MINUTES
WORCESTER TOWNSHIP PLANNING COMMISSION
WORCESTER TOWNSHIP COMMUNITY HALL
1031 VALLEY FORGE ROAD, WORCESTER, PA 19490
THURSDAY, DECEMBER 12th, 2024 - 7:00 PM

COMMERCE PURSUIT CAPITAL
TROOPER RIDGE SUBDIVISION
1035 NORTH TROOPER ROAD, WORCESTER TOWNSHIP
MONTGOMERY COUNTY, COMMONWEALTH OF PENNSYLVANIA
STORM PROFILE-1

1035 Trooper Road
MCPC#240066002

PROJECT INFORMATION:
FILE PATH: G:\Projects\WDEV\0000A\Plans\1
FILE NAME: WDEV0000A_PRF -ROAD.dwg
DATE: 12/19/2024 6:17PM
LAST SAVE BY: SRobert

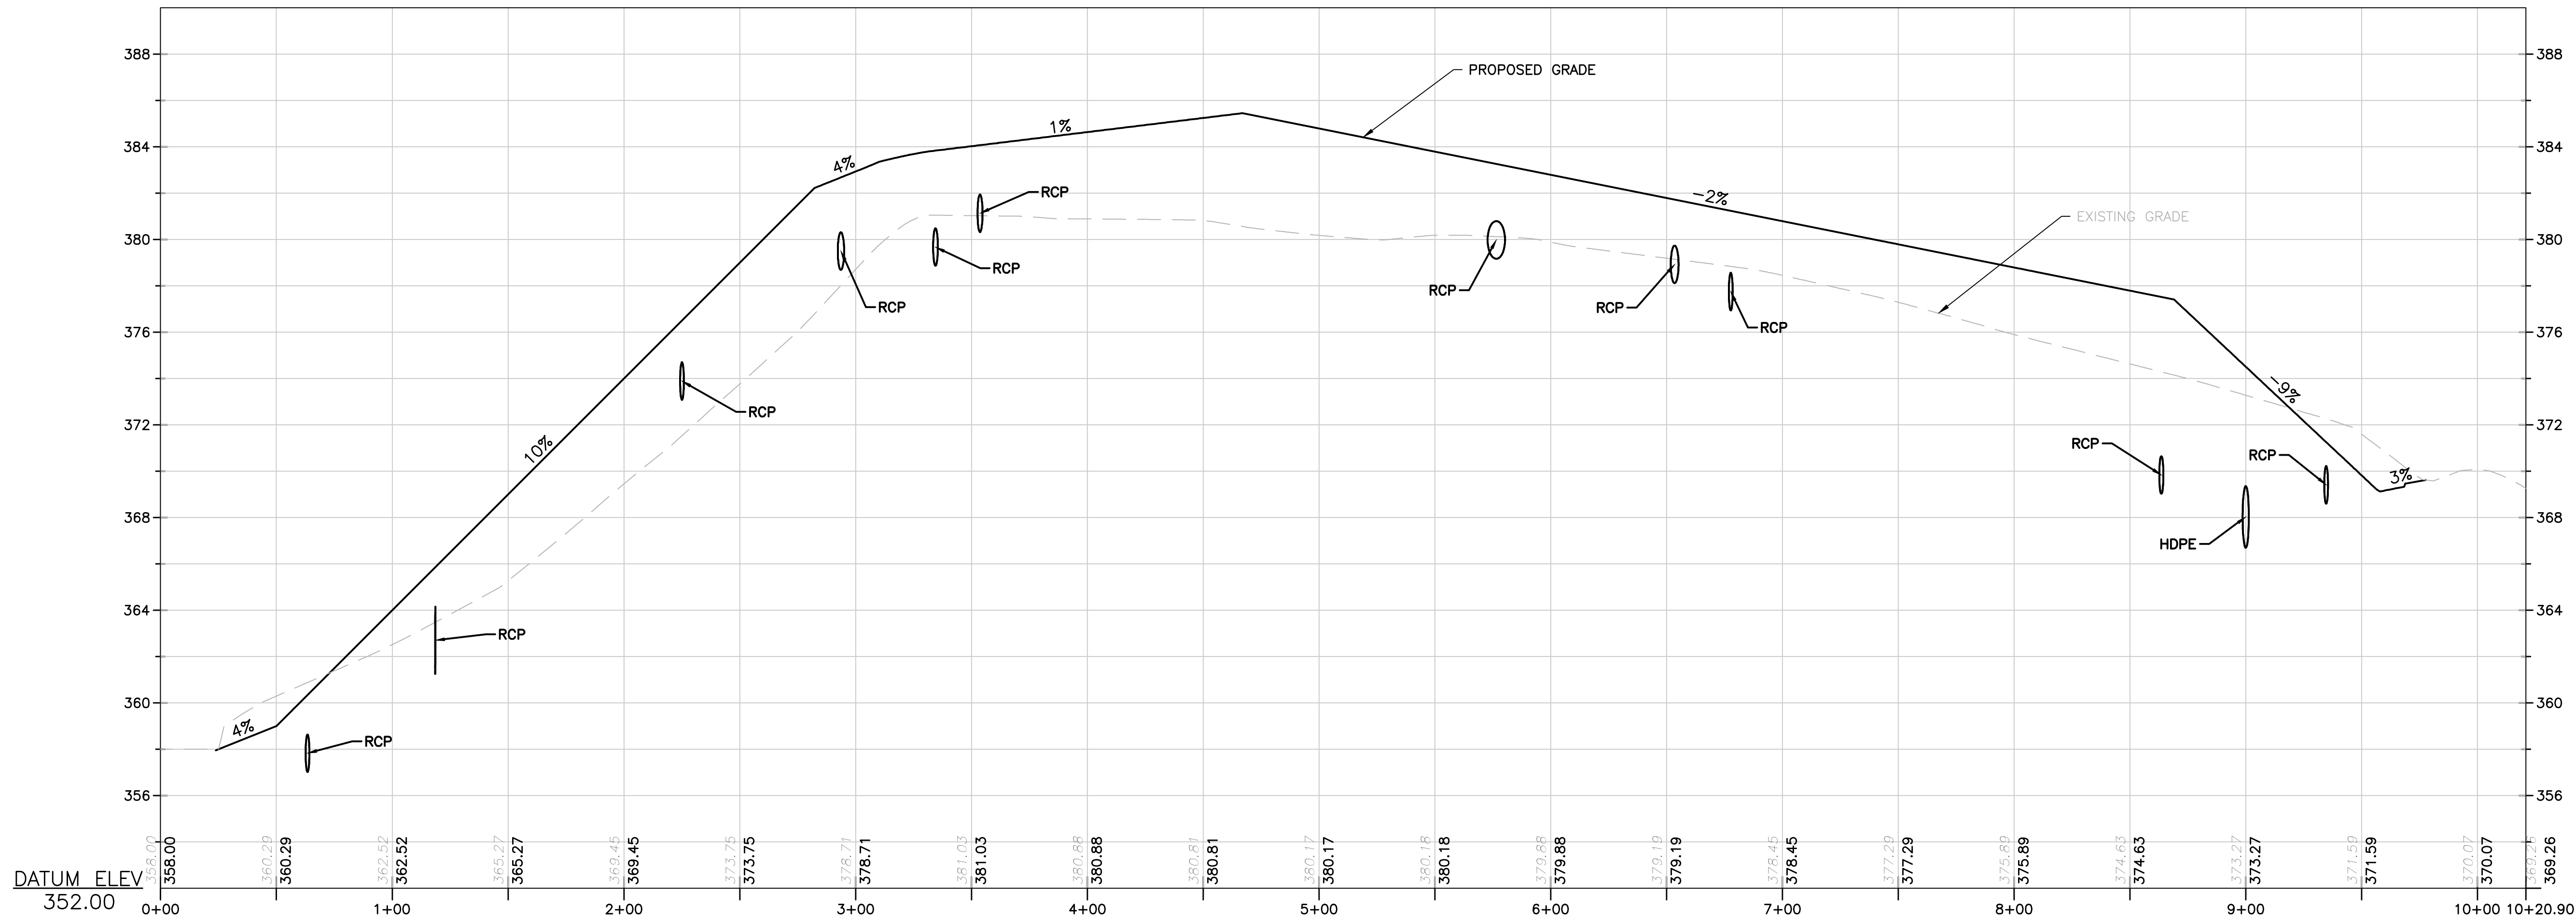
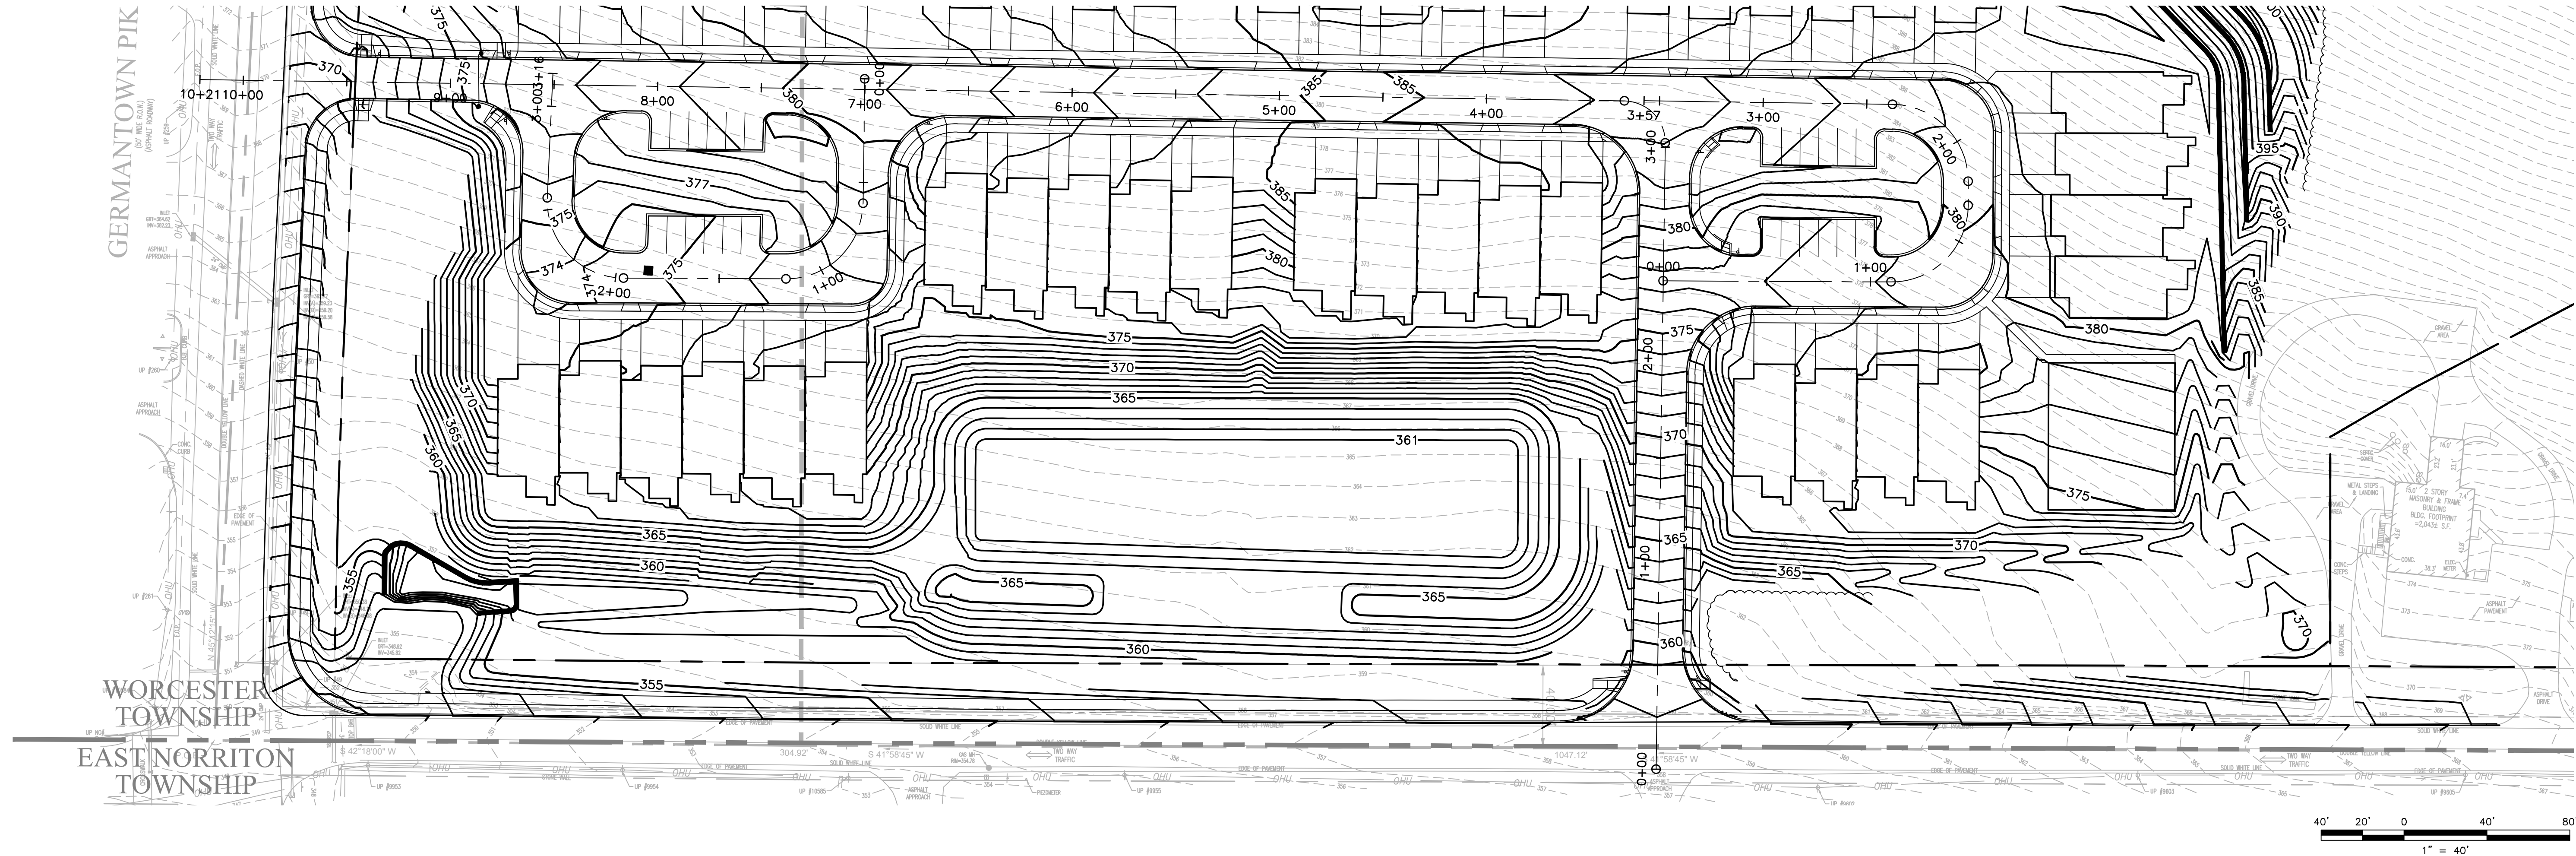
37. The proposed profiles on Sheets 20-22 should be updated to provide the proposed elevations on the bottom informational band.
38. The proposed crosswalk areas must be shown on the proposed profiles and have ADA compliant slopes.

17. The intersection approach to Trooper Road from the main access road and to the cross street northwest of the north loop has a slope of 4% per the Sheet 20 profile. This must be reduced to 3% for a minimum distance of 50 feet at both locations, or a waiver requested. We defer to the Township Traffic Engineer for further comment. (130-16.E.7)
